# PERMIT

SEWAGE DISPOSAL SYSTEM

MARYLAND STATE DEPARTMENT OF HEALTH

PERMIT CARD

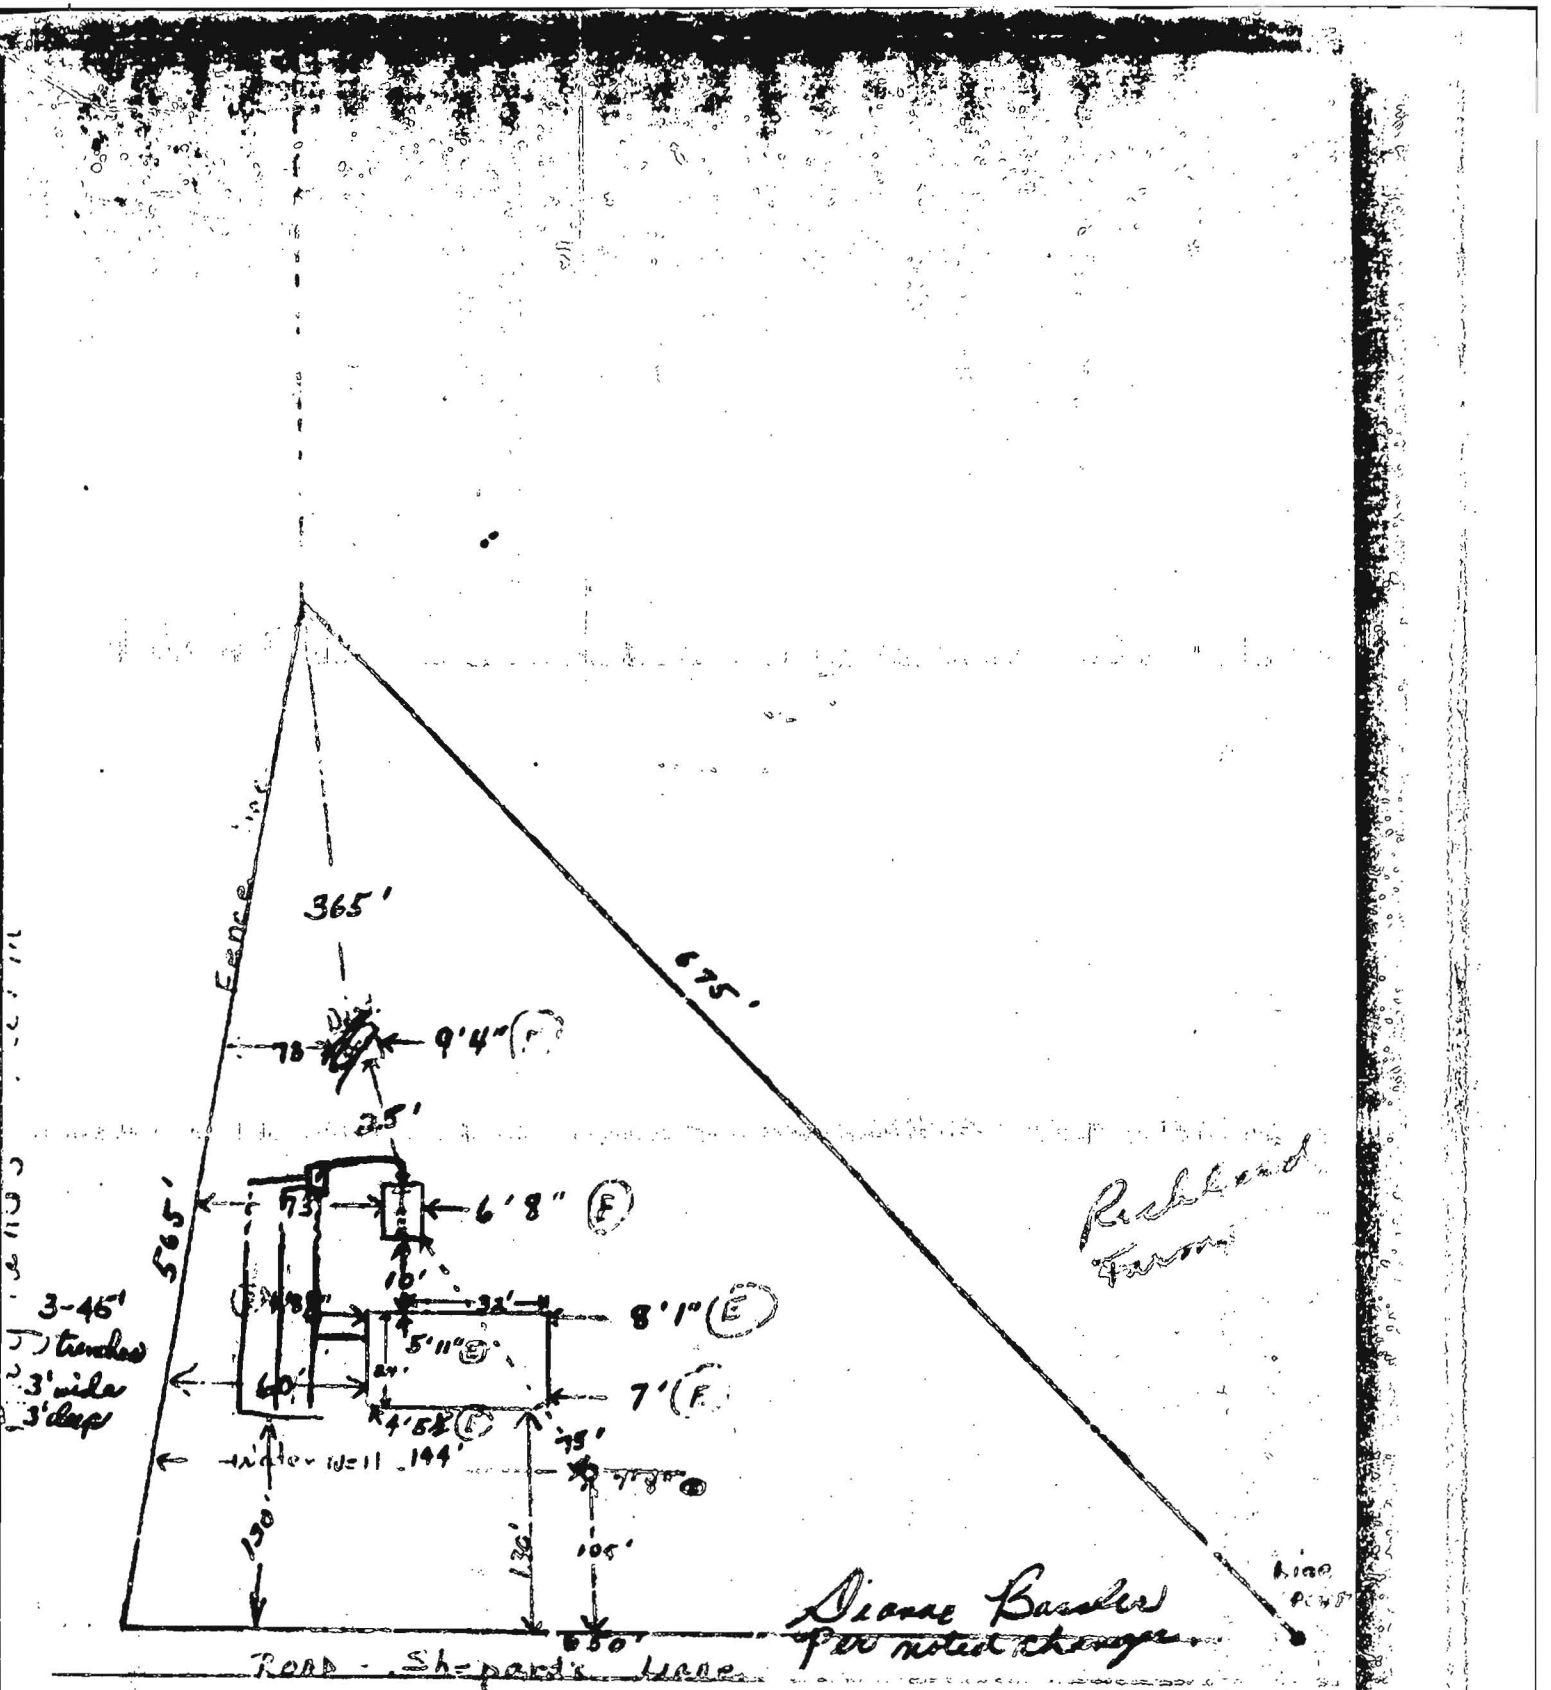
REMARKS *11/10/71 Distillation pit 2' below ground; 3' depth all along tile. Sewer. Partial (1) + (3) trenches 7' ft. below ground; Septic Tank needs a clean out. C.R.S. 10/91 No change. 12/10/71 S.T. Cleanout OK*

DATE SYSTEM APPROVED 12/10/71 INSPECTOR C. Stricker
